AGENDA  
Architectural Design Review Board  
Tuesday, June 7, 2016

**To:** Architectural Design Review Board  
**From:** Ed Wilson, ADRB  
**Subject:** **AGENDA ITEM – Old Business #1**  
**232 North Second Street – Gable Window Replacement**  
 Marion Arbino, Applicant  
 Meeting Date: **6/7/2016**  
**Tabled:** **5/17/2016**  
*Received Application:* **5/4/2016**  
**Impacts:** German Village Historic District

## 232 North Second Street Gable Window Replacement

**To:** Architectural Design Review Board  
**From:** Ed Wilson, ADRB  
**Subject:** **AGENDA ITEM #1**  
**321 Ross Avenue – Rear Portion, Exterior Work (Roof Work, Box Gutters, Soffit Painted, New Rafter)**  
 Gerry Richter, Applicant  
 Meeting Date: **6/7/2016**  
 Received Application: **5/24/2016**  
**Impacts:** Rossville Historic District

**EXHIBIT B: Comparative Before & After Images of 232 North Second Street**

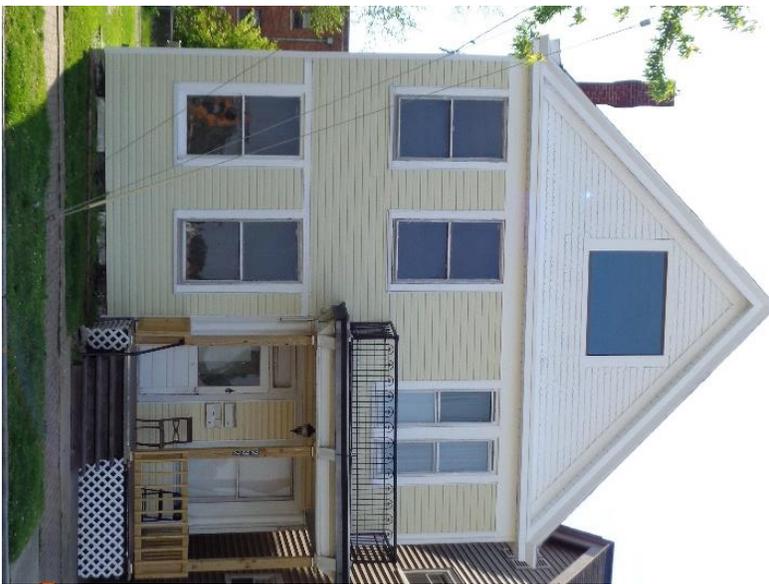
*At the May 17<sup>th</sup> 2016 ADRB meeting, the board considered the style of both the Previous Gable Window and the Current Gable Window. This was the arguably the primary concern expressed by board members at the meeting.*

*The previous gable window consisted of smaller mullion windows flanking a central arched window, which itself contained a grid style matching the mullions for the upper half arch.*

*The current gable window is a simple squared window with no grids.*

*At the May 17<sup>th</sup> 2016 ADRB meeting, the board also considered the dimensions of both the Previous Gable Window and the Current Gable Window.*

*The previous gable window appeared to take less of the gable space.*

*The current gable window appeared to take more of the gable space.*

*In general, the board expressed reservations related to the simple shape of the current gable window, compared to the mullion-arch window-mullion pattern of the previous window. As specified previously, the Applicant expressed on multiple occasions that the current window was to improve the property and take advantage the view of adjacent amenities such as RiversEdge.*

*At the May 17<sup>th</sup> 2016 ADRB meeting, the board noted the current gable window did not match the style of the previous gable window. As a reprise, the Applicant noted that the new window was to take advantage of the view from the attic, overlooking RiversEdge and the upcoming Marcum Park.*

*The board noted the visual difference in dimensions between the current gable window and the previous at the May 17<sup>th</sup> ADRB meeting.*

*However, Construction Services evaluated the gable window and noted the current window uses the same header as the previous window.*
